Access Compliance Report

Public Rights-of-Way

Intersection ID: 48867	Main Street: ERWIN_RD	Cross Street: LION_CUB_LN	Location: SE
ADA ID: 1FE2CC024A43	Ramp Type: BlendTrans1	Initial Pass/Fail: Pass	Overall Compliance: No
		Severity Score: 5

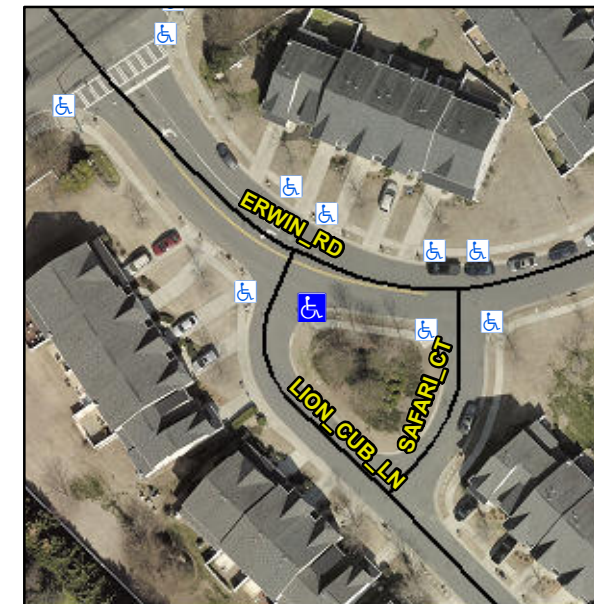
Not Found, R304.2.1, R304.5.4, R304.5.3

N/A	Ramp inside XWalk1?	N/A	N/A	Ramp inside XWalk2?	N/A
	Road Slope (%)	1.8		Clear Space?	Yes
	Road X Slope (%)	1.4	N/A	Clear Space to XWalk (in)	N/A
Yes	Any Obstructions?	No	Yes	Storm Grate/Utility Hazard?	No
	Obstruction Type			Storm Grate/Utility Type	
		N/A			N/A
			Yes	Surface Condition? (G/P)	Good
			No	Curb Slope (%)	14.3

Remove & Replace Curb Ramp With Two New Directional Ramps or Equivalent. Remove & Replace Gutter.
